AMENDMENT NO. 14 TO BIDDING DOCUMENTS (TECHNICAL SPECIFICATION)

KHURJA SUPER THERMAL POWER PROJECT (2X660 MW) TURBINE GENERATOR AND ASSOCIATED PACKAGES		TECHNICAL SPECIFICATION SECTION – VI, PART-C BID DOC. NO.: THDC/RKSH/CC-9915-371	GENRAL TECHNICAL REQUIREMENTS (GTR)	PAGE 1

LAYOUT OF DRAINS

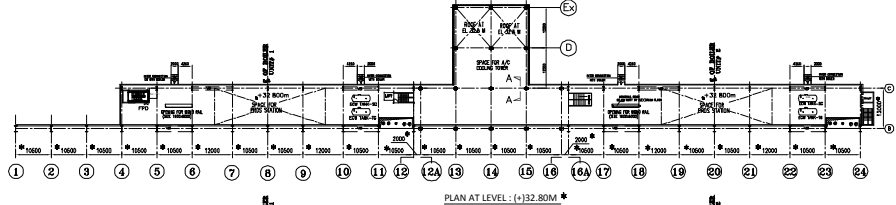
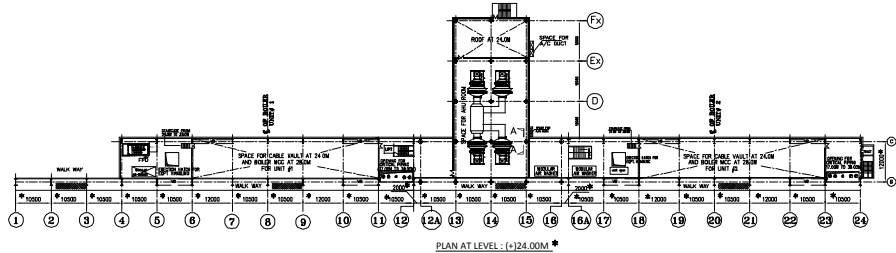
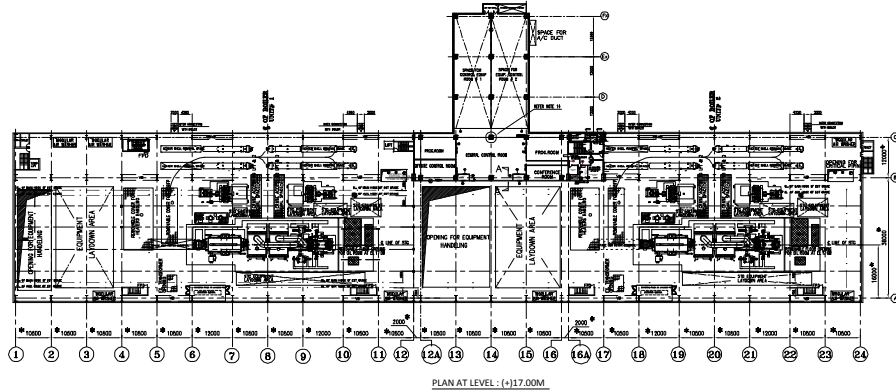
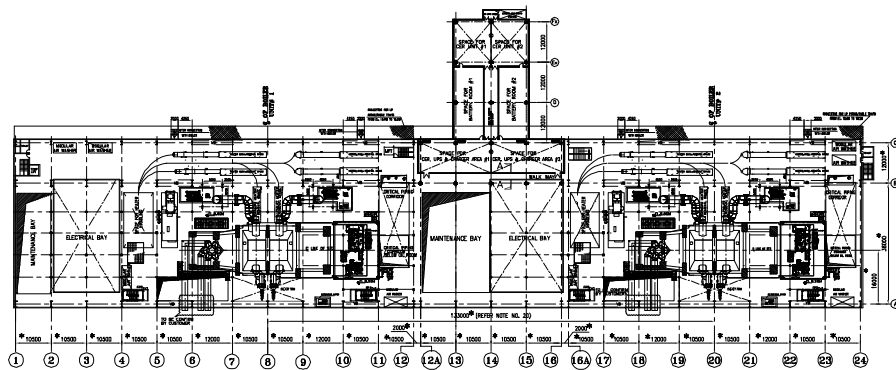
34	Ame ndm ent No. 7		1 of 1	S.No. 2	 9915-371-POC-A-002 titled "Layout of Roads" and 9915-371-POC-A-003 titled "Layout of Drains" added for information purpose only	 9915-371-POC-A-002 titled "Layout of Roads" Rev-B and 9915-371-POC-A-003 Rev-C titled "Layout of Drains" added for information purpose only
35	VI/ E	Tend er drawi ng		Sl.No.- 3	Layout plan at 8.5M/17.0M/24.0M/24.0M/28.0M/32.0M/38.0M, Drg No- 9915-999-POM-F-002 (Rev-A)	Layout plan at 8.5M/17.0M/24.0M/24.0M/28.0M/32.0M/38.0M, Drg No- 9915-999-POM-F-002 (Rev-B)
36	VI/ A	A2	3 of 3	1.07.0 1	Contractor shall prepare 3D design review model (network ready, which shall include visual interference check, walk-through animation, video simulation for major equipment placement and removal, visual effect, photo realism etc), which is extracted from intelligent 3D model, for employer's review as & when desired by employer. However, all piping layouts, equipment layouts, floor plans, ducting layout (Air/flue gas, A/C, Ventilation etc.), structural arrangement drawings and RCC layout drawings shall necessarily be extracted from the aforesaid 3D model and submitted for employer's review along with the 3D review model to enable NTPC to review and approve these drawings.	Contractor shall prepare 3D design review model (network ready, which shall include visual interference check, walk-through animation, video simulation for major equipment placement and removal, visual effect, photo realism etc), which is extracted from intelligent 3D model, for employer's review as & when desired by employer. However, all piping layouts, equipment layouts, floor plans, ducting layout (Air/flue gas, A/C, Ventilation etc.) and structural arrangement drawings shall necessarily be extracted from the aforesaid 3D model and submitted for employer's review along with the 3D review model to enable Owner to review and approve these drawings
